City of San Diego
Planning Department

Environmental Impact Report

EQD No. 84-0160
SCH No. 84030708

SUBJECT: Sea World Master Plan. COUNCIL ADOPTION of a Master Land Use Plan as a condition of a 32-acre, 50-year ground and water lease negotiated by Sea World and the City Manager. Key features include expansion of the theme park, marina and parking areas. Located between Sea World Drive and Mission Bay just east of Ingraham Street in the South Shores area of Mission Bay Park. Applicant: Sea World, Inc.

FIGURE
4-4

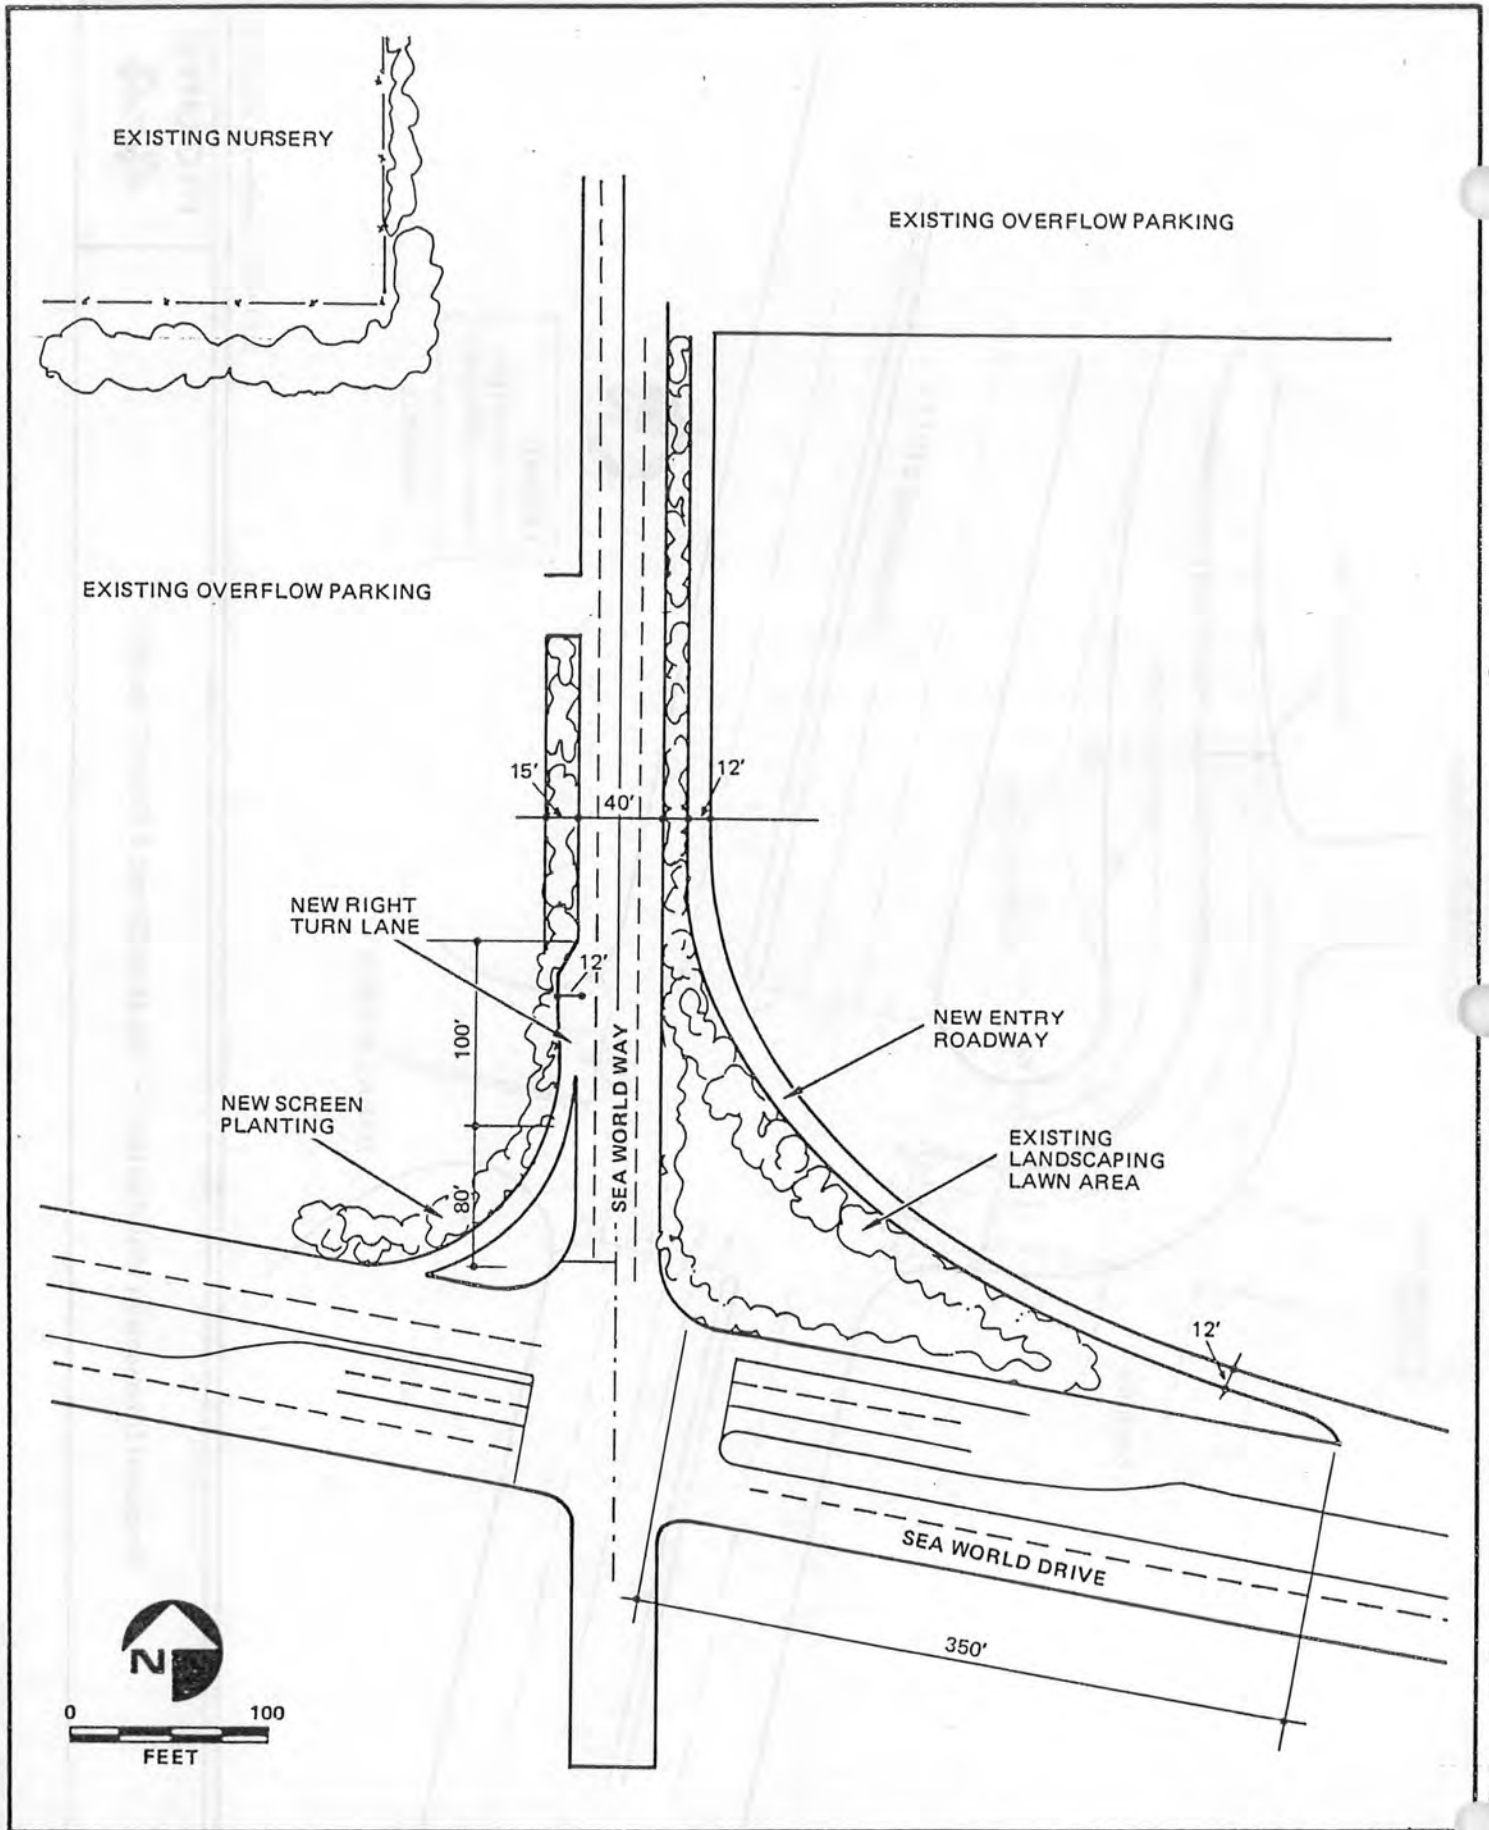
1. Prior to occupancy of the proposed hotel, Sea World shall complete and open to traffic the following:
 - a. Improve Perez Cove Way/Ingraham Street Intersection as shown in EIR Figure 4-4 (Perez Cove Way to be 66 feet wide). (This mitigation will not be required prior to widening of the Ingraham Street Bridge at Mission Bay Channel.)

- b. Reconstruct Driveway Access to Perez Cove Way as shown in EIR Figure 4-4 (Perez Cove Way to be 66 feet wide).
2. When the annual attendance at the theme park reaches 3,600,000 per year, Sea World shall relocate Sea World Way approximately 500 feet east along Sea World Drive and construct Sea World Way to its ultimate configuration (52 feet), plus all turn lanes to and from Sea World Way. Sea World shall also remove the old traffic signal and install new signals to City standards. This would also include the installation of sidewalks, and preservation of landscape buffers installed during earlier development phases.

FIGURE 4-8

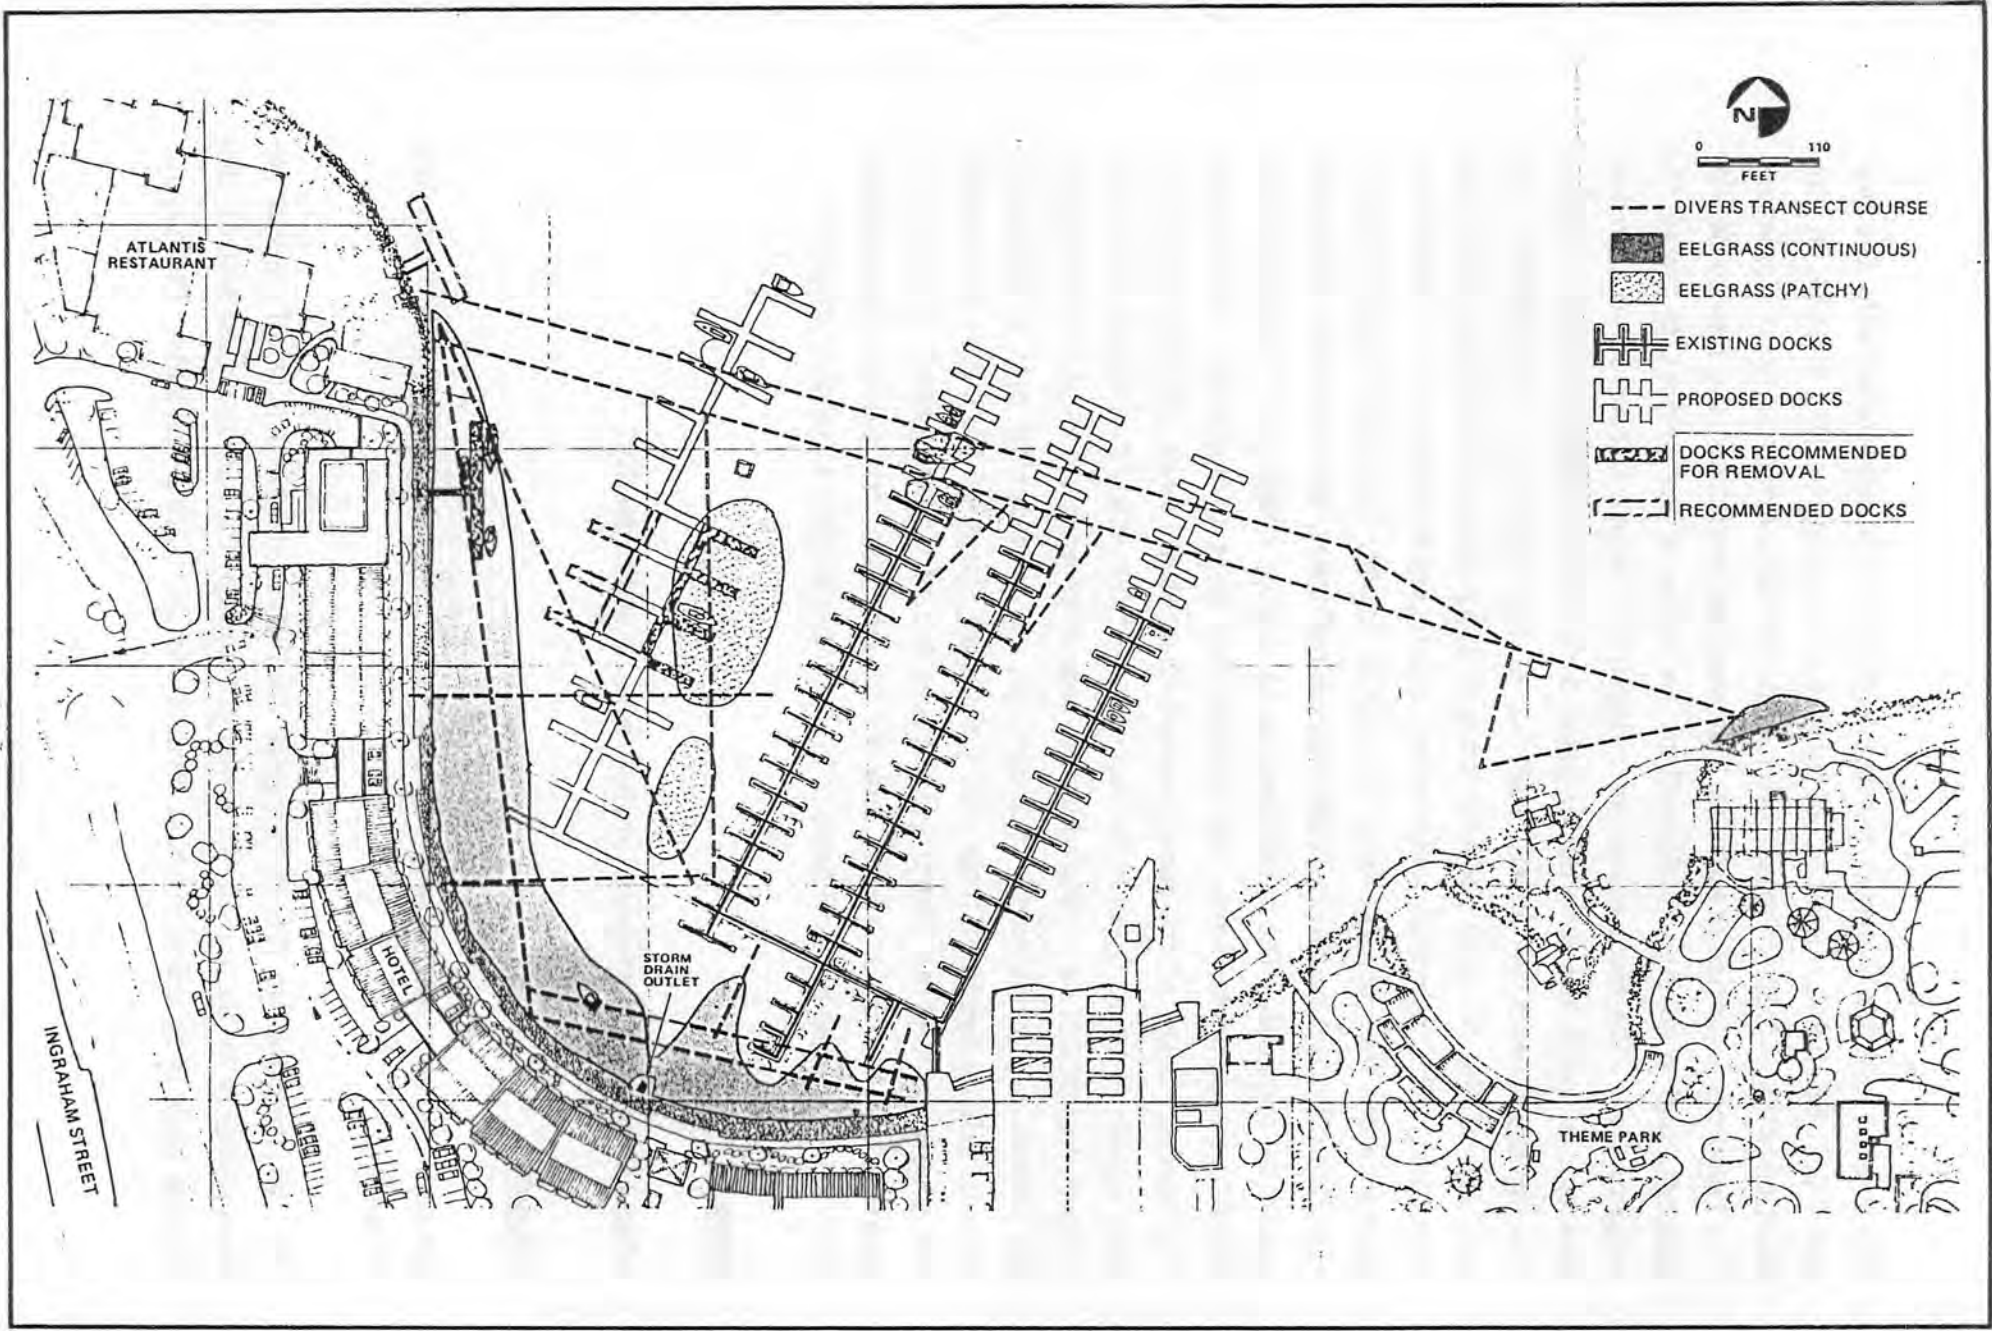
18. 2. The proposed additional docks would eliminate approximately 6,250 square feet (0.14 acres) of an existing eelgrass bed. The applicant has recommended (Page 3, Biological Resources) that prior to approval of the marina expansion a revised dock design as depicted on EIR Figure 4-8 shall be incorporated into the marina expansion plan. This revised dock design will significantly reduce impacts to the existing eelgrass bed. However, there will still remain a loss of eelgrass. This loss could be reduced further or eliminated by deletion of the southwestern dock. Therefore, we recommend that the proposed marina incorporate the dock design depicted on EIR Figure 4-8, and that the southwestern dock (depicted on Figure 4-8) be deleted from the project design.

18. The recommended dock design shown in Figure 4-8 is subject to further review by the San Diego Planning Department and the regulatory agencies having jurisdictional authority. While this proposed design mitigates the significant impact to eelgrass, deletion of the single southwestern-most dock (extending westward) would provide additional mitigation which the agencies may require during future review of the design.

19. Comment acknowledged, no response necessary. The proposed recommendation will be implemented as indicated in Figure 4-8, page 4-40, of the EIR.
